Malibu Creek Ecosystem Restoration Study
Los Angeles and Ventura Counties, California

Appendix U

**Resource Agency Coordination Documents
(ESA and 401)**

SUBJECT: Malibu Creek, California Feasibility Study, Section 7 of the Endangered
Species Act (ESA) Policy Exception Request

Figure 3 Restored Aquatic Habitat Connectivity - Upstream Barriers

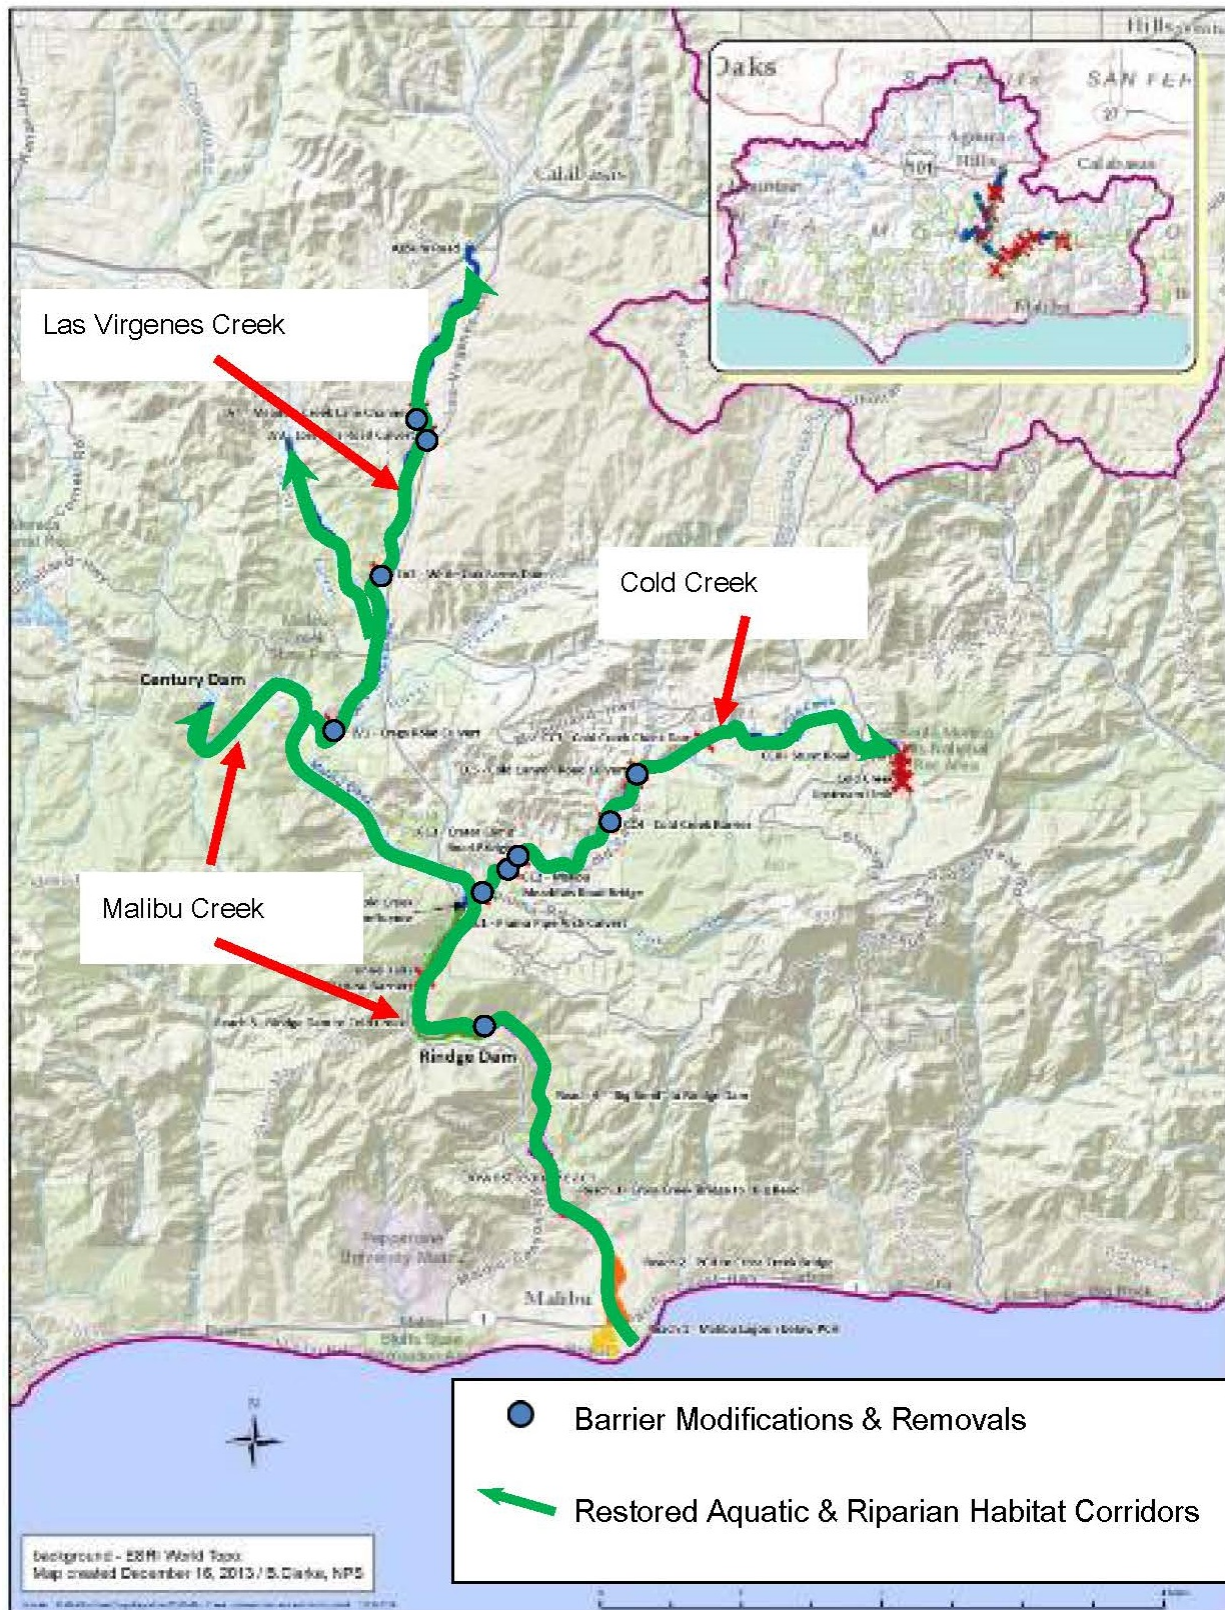
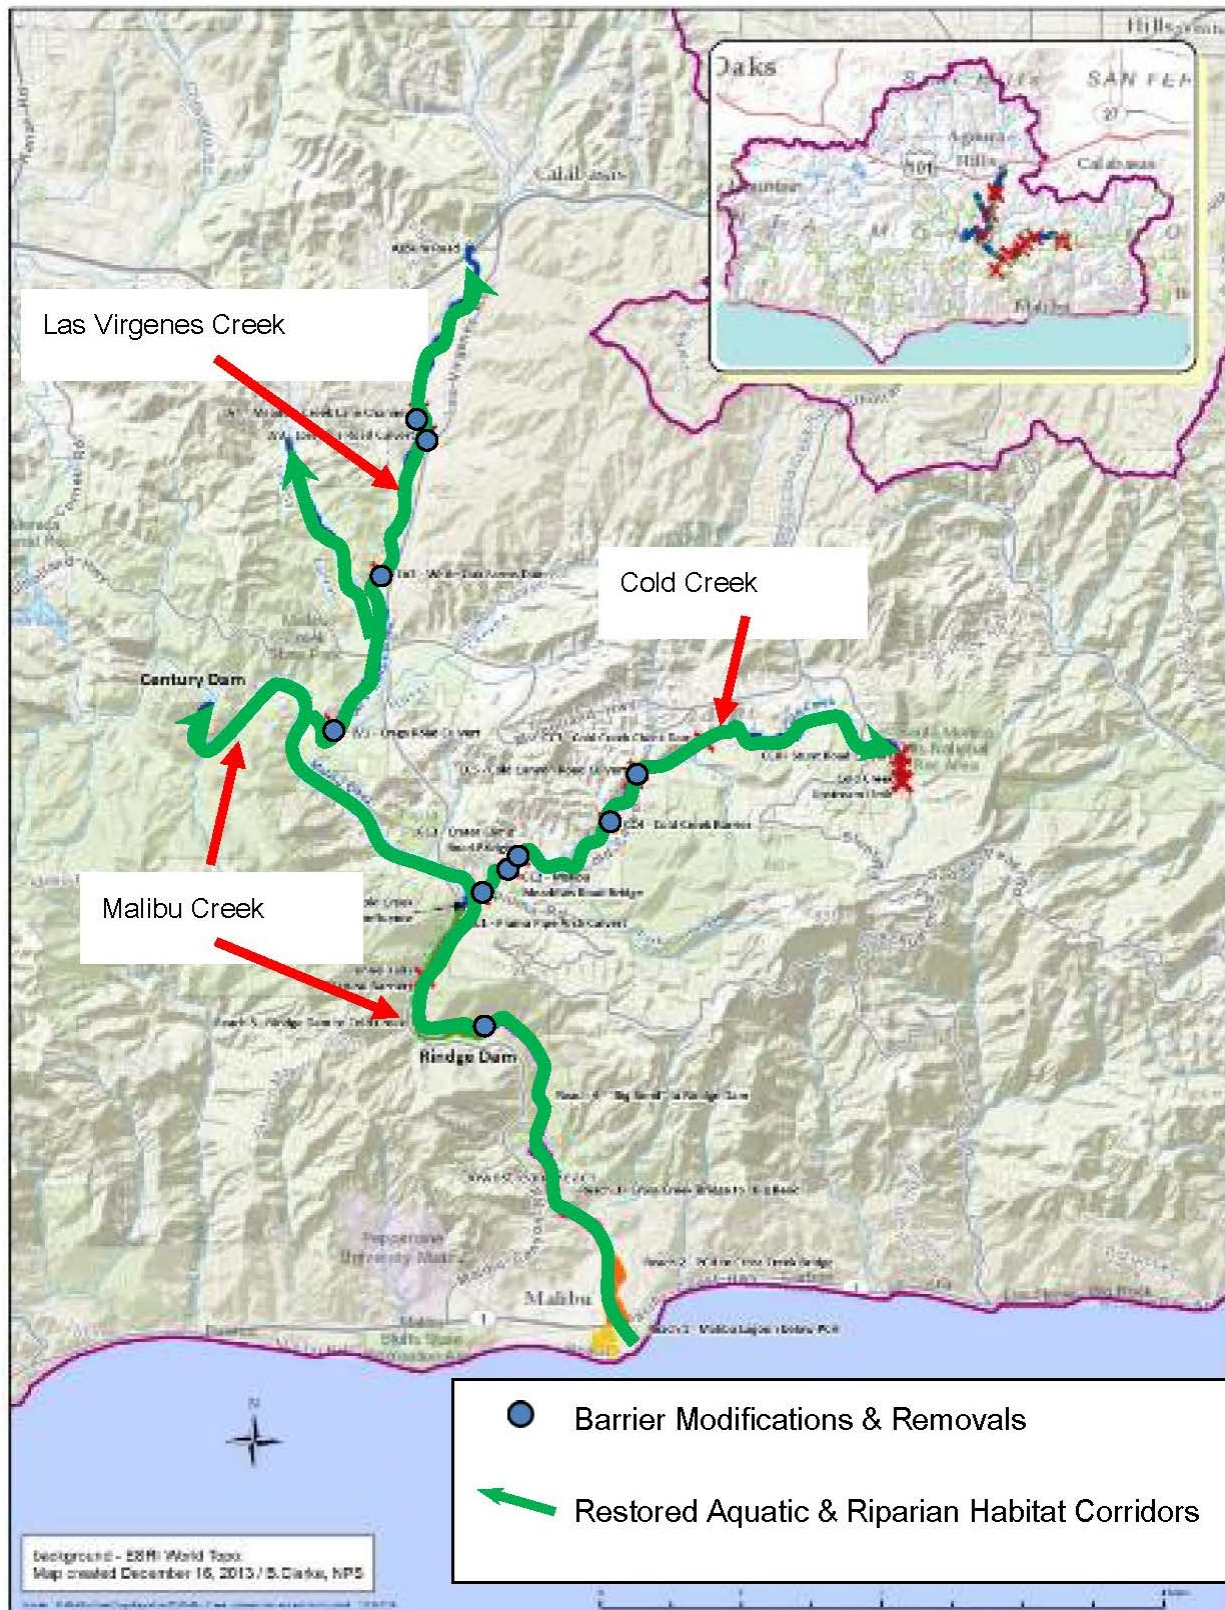
Action Area.—This section of the BA should be updated to better define the location and extent of specific components of the proposed action. Although Figure 3 (BA at pg. 7) is referenced as the “Action Area” individual components of the proposed action and associated project footprints are not clearly identified. For each component of the proposed action, describe the instream linear extent (upstream and downstream) of the work area. Additionally, the action area description should account for the upstream and downstream extent of any potential effects, which can transcend the physical location of a construction activity.

- Clarify whether eight upstream barriers (pg. 9) or nine (Figure 3) will be removed or modified.
- Clarify the following statement “Habitat Evaluation outputs remain the same as those calculated for the NER Plan, but overall costs increase (pg. 10).”

There are eight upstream barriers to be removed. Figure 3 in the BA, shows nine, one has been removed by another group and is no longer part of the project.

Figure 2. Rindge Dam Schematic Sediment Removal Plan

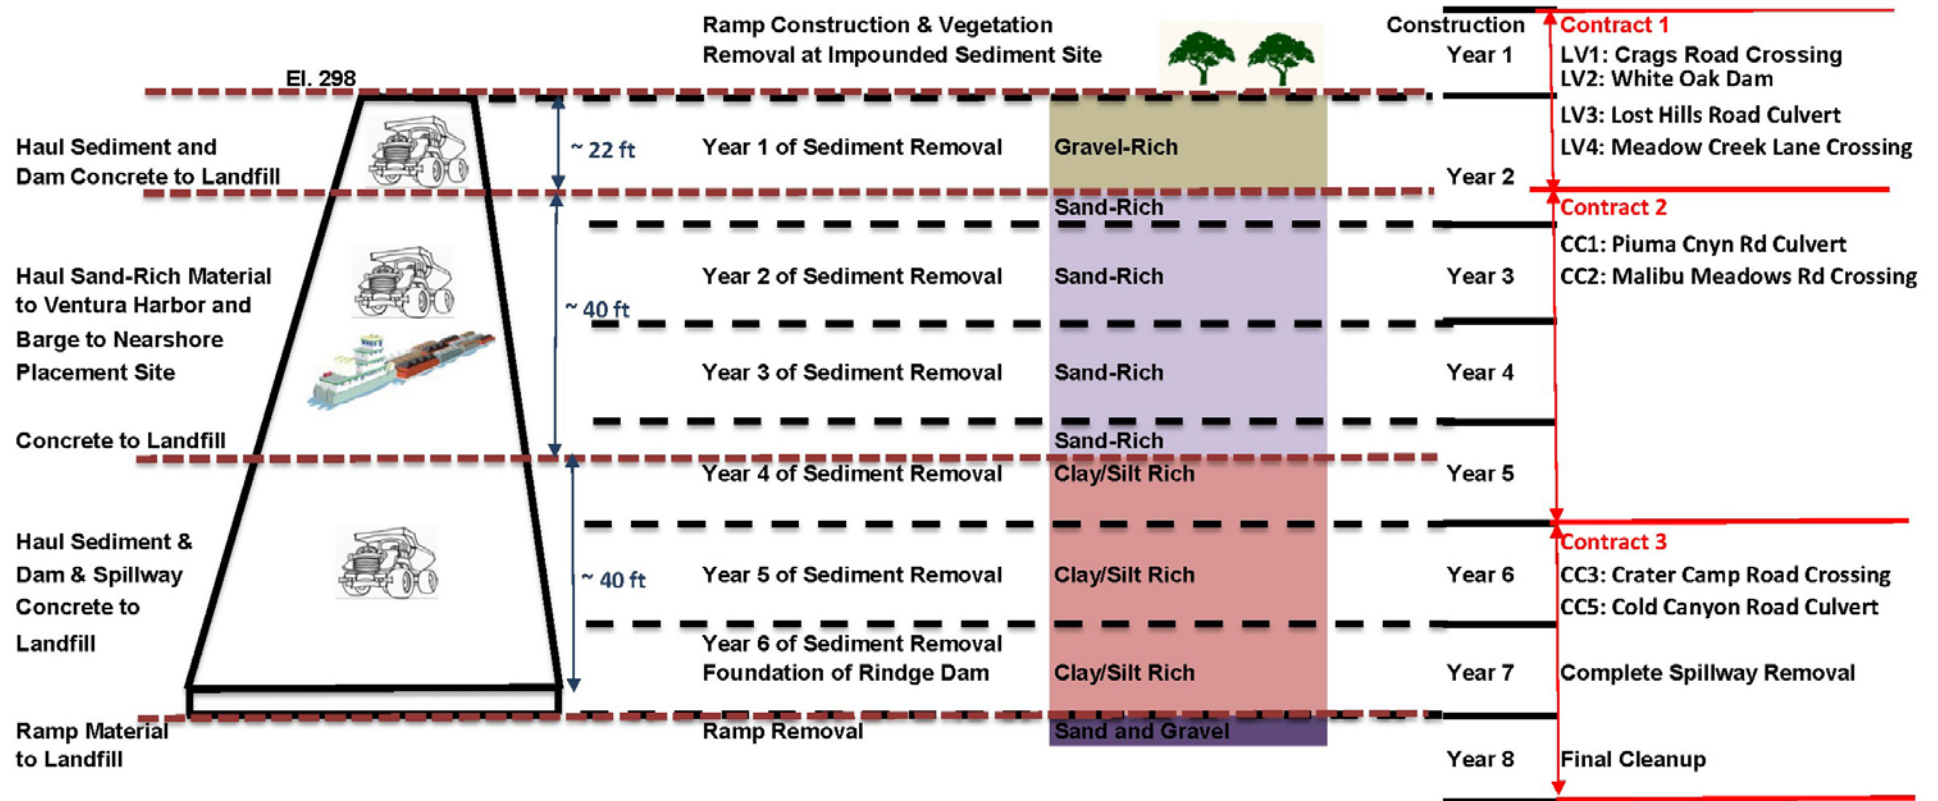
4. A design drawing depicting the sections of dam and spillway to be removed incrementally over the 8 years of construction. The schematic provided by the Corps does not clearly identify the dam crest or spillway elevations following each season of construction (Corps 2018, Fig. 2). Provide design plans or drawing that clearly depicts existing dam crest and spillway elevations, and subsequent dam crest and spillway elevations following removal of sediment each season.

A design depicting the sections of dam to be removed incrementally is shown on Figure 2. The spillway would be removed sometime during year 4.
